**INTERIM CHANGE NOTICE
 (ICN)**

<p>A. Document No.: PNNL-13023 Revision No.: 1</p> <p>Document Title: RCRA Groundwater Monitoring Plan for Single-Shell Tank Waste Management Area A-AX at the Hanford Site</p> <p>Document's Original Author: S. M. Narbutovskih and D. G. Horton</p>	<p>Effective Date of ICN: July 15, 2002</p> <p>Change Requested By: S. M. Narbutovskih</p>
<p>B. Action: Make changes in the monitoring plan as described below in Section D. Attach this ICN to the front of the document just before the title page.</p>	
<p>C. Effect of Change: This ICN documents an improved understanding of the local groundwater flow direction, defines up gradient versus down gradient monitoring wells, provides updated critical means for indicator parameters and updates the sampling and analysis schedule. Project scientist will provide a schedule change request providing a list of constituents and sample frequencies to the sample scheduler.</p>

<p>D. Reason for Change/Description of Change:</p> <p>Reason for Change: Update groundwater quality monitoring plan at WMA A-AX (PNNL-13023) to document an improved understanding of the local groundwater flow direction, to redefine up gradient versus

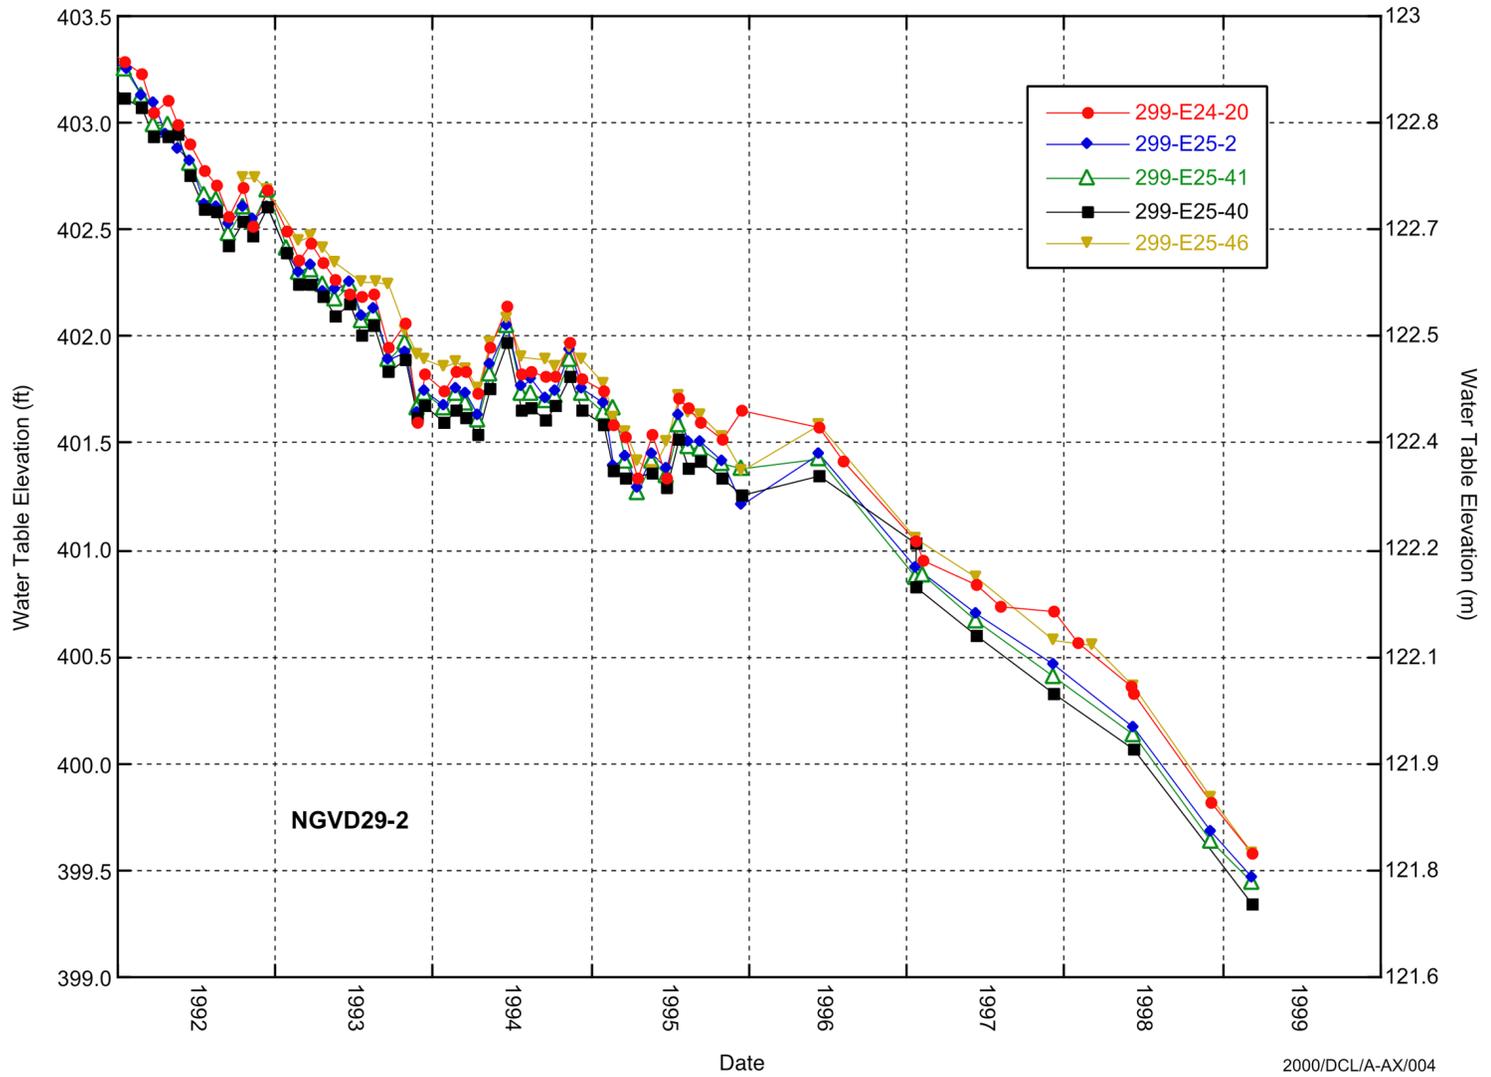
For example, Figure 2.7 shows the hydrographs for four RCRA network wells and one older well 299-E25-2, that are currently used to monitor the water table at WMA A-AX referenced to NGVD29-2. Spurious data were removed. Figure 2.8 shows the same 'depth to water' data as Figure 2.7 but referenced to NAVD88 except for well 299-E24-20. For this well, the NAVD88 reference elevation was calculated from the original NGVD29 elevation. The hydrograph in Figure 2.7 is using a survey conducted in the early 1990s, whereas the hydrograph in Figure 2.8 uses a survey from the late 1990s. Except for well 299-E25-46, the relative elevations of the wells appear to be almost unaffected by switching surveys, demonstrating repeatability of the elevation values. The reference elevations from these wells, therefore, are probably reliable. Although the absolute difference is small, the relative position of the water table in well 299-E25-46 switches from being high in Figure 2.7 to being lower with respect to the other wells in Figure 2.8. This difference is enough to demonstrate some degree of nonrepeatability for the well. The late 1990s survey used in Figure 2.8 is considered more reliable.

Figure 2.8. Hydrograph Showing Groundwater Elevations Referenced to the Datum, NAVD88, and a Late 1990's Survey, Except for Well 299-E24-20. Spurious data have been removed.

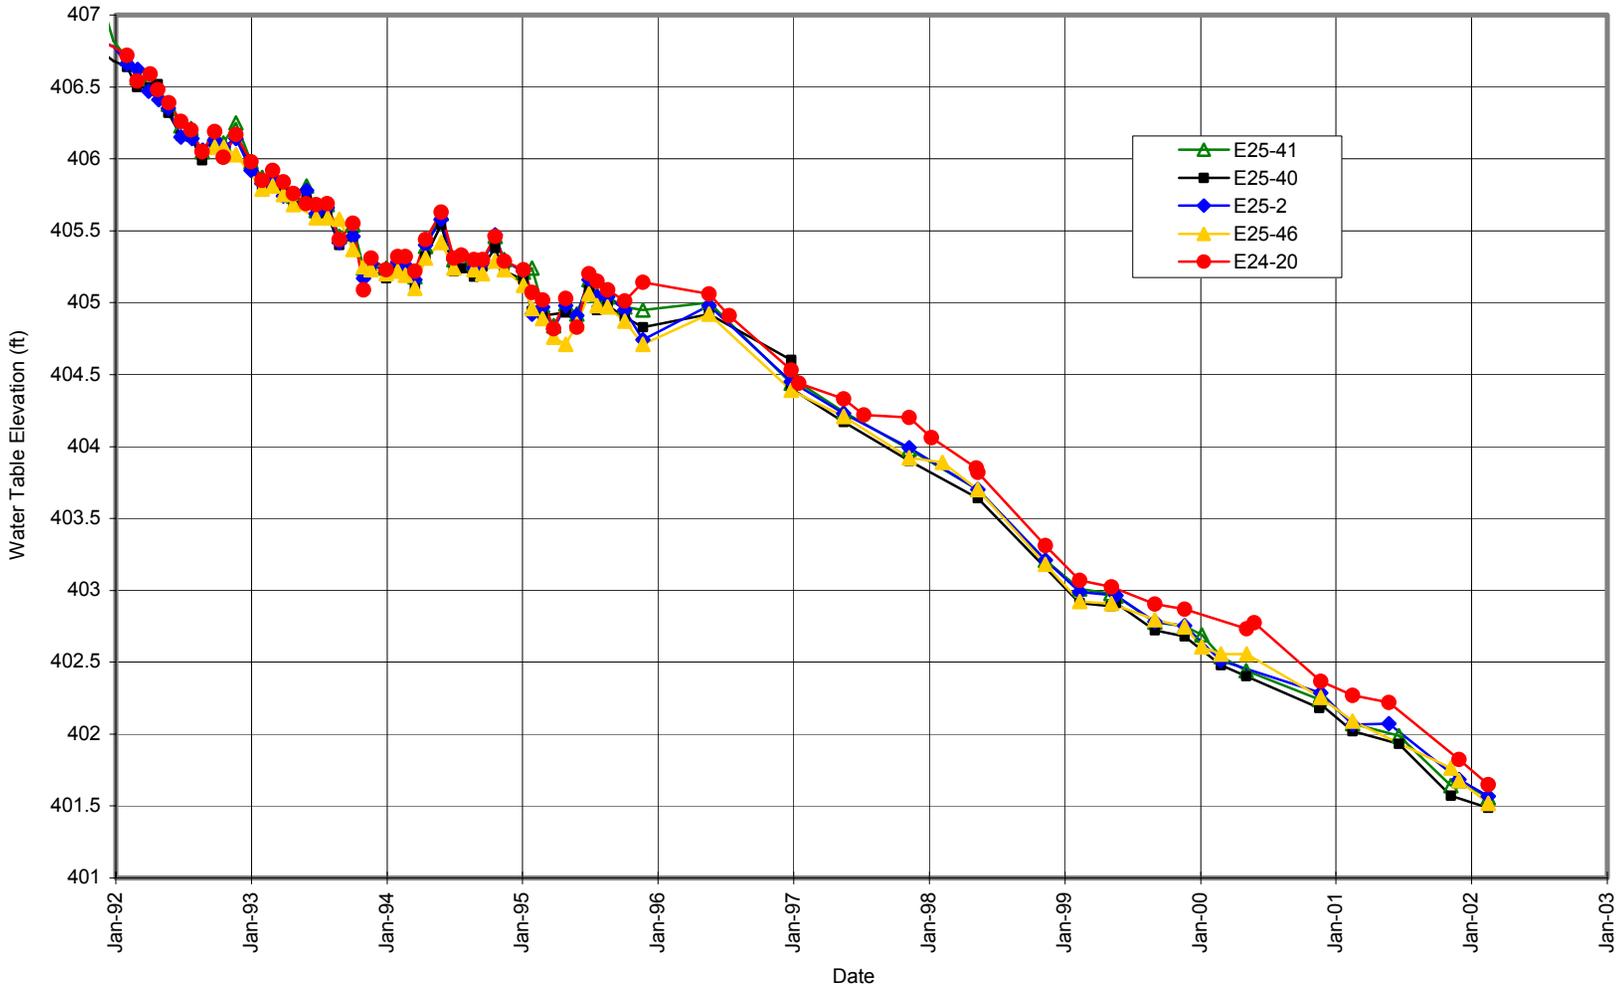
Hydrographs of the five wells gives a consistent picture of relative water elevations over time (Figure 2.8). The flow direction appears to be east to southeast. Based on these hydrographs, well 299-E24-20 is the upgradient well, while the others are down gradient. This scenario results in a generally east to southeast direction across the site. This direction has been confirmed with the use of an alternative in situ method to determine flow direction. Recent direct measurements using the colloidal borescope in wells 299-E25-46 (southeast of A tank farm), 299-E25-41 (southeast of AX tank farm), and 299-E25-42 (southeast of A Tank Farm) indicate a southeasterly flow direction.

Figure 4.1. Map of Wells Around Waste Management Area A-AX Showing Flow Direction Based on Colloidal Borescope Measurements

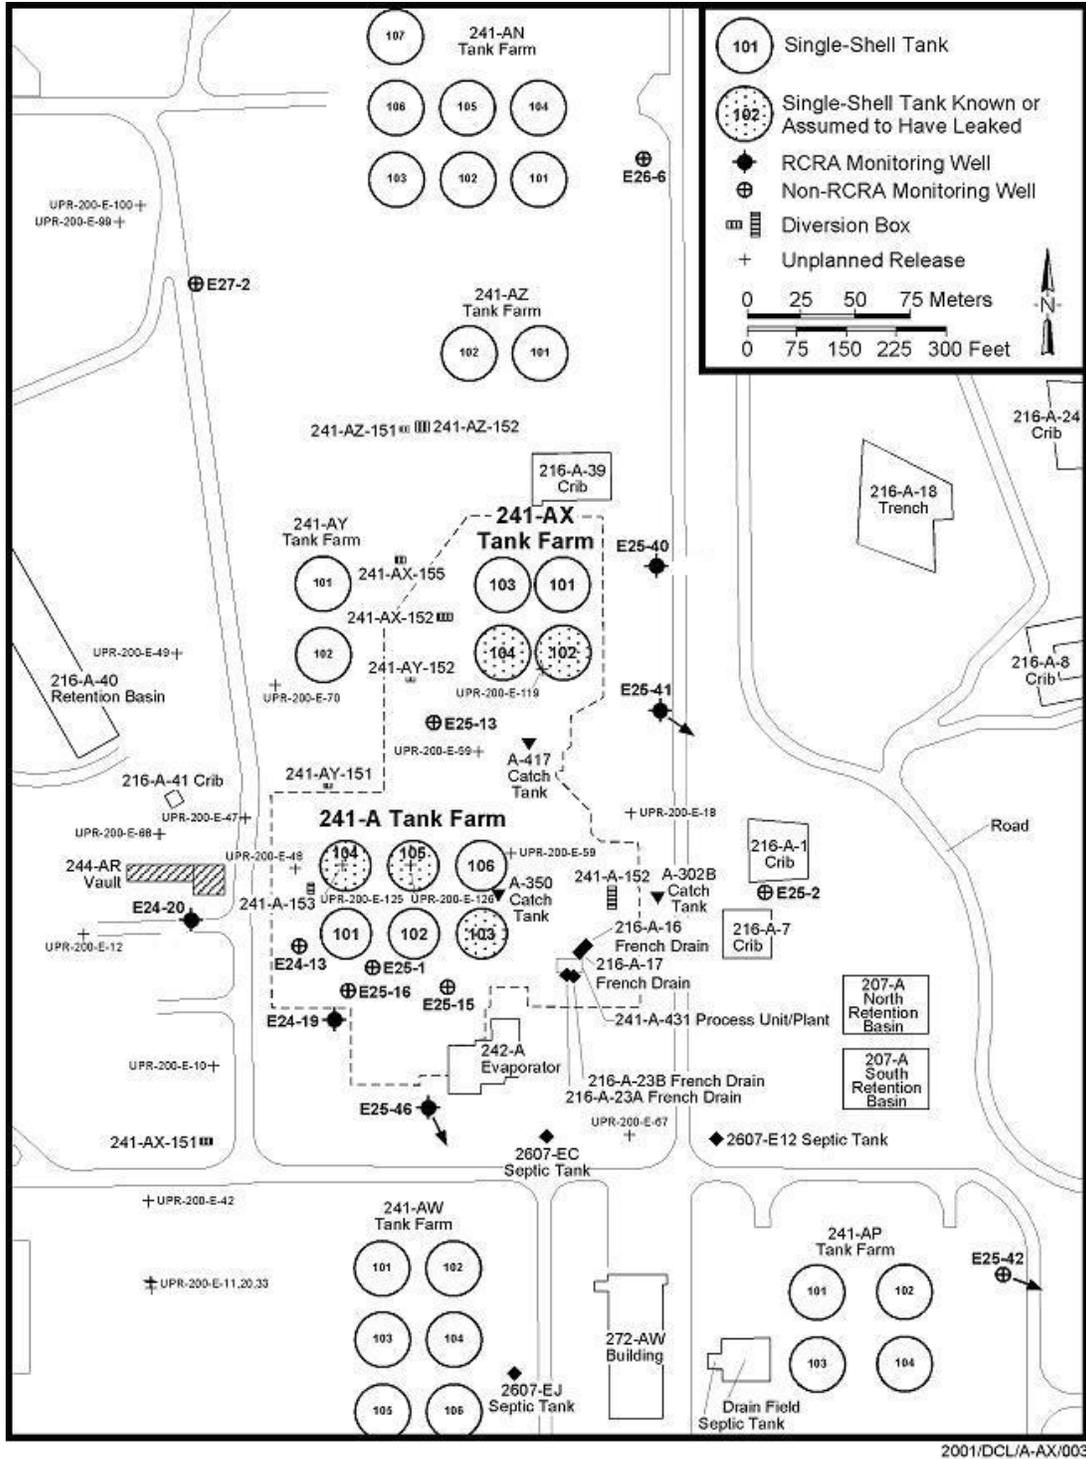
- Based on consistent water levels and a recent colloidal borescope investigation, the predominant flow direction is to the southeast from the WMA A-AX.

Because water levels do not assure determination of the flow direction, colloidal borescope investigations were used to increase the level of confidence in flow direction and rate. The colloidal borescope is an in situ technique used to directly measure the flow rate and direction through the well screen by digitally recording the movement of colloidal particles through the open interval in the well. Results of its use at Hanford indicate that the tool can provide useful, reliable information on flow properties in both the highly permeable Hanford formation and less permeable Ringold Formation sediments when properly deployed and used in conjunction with water level and other types of flow direction data.
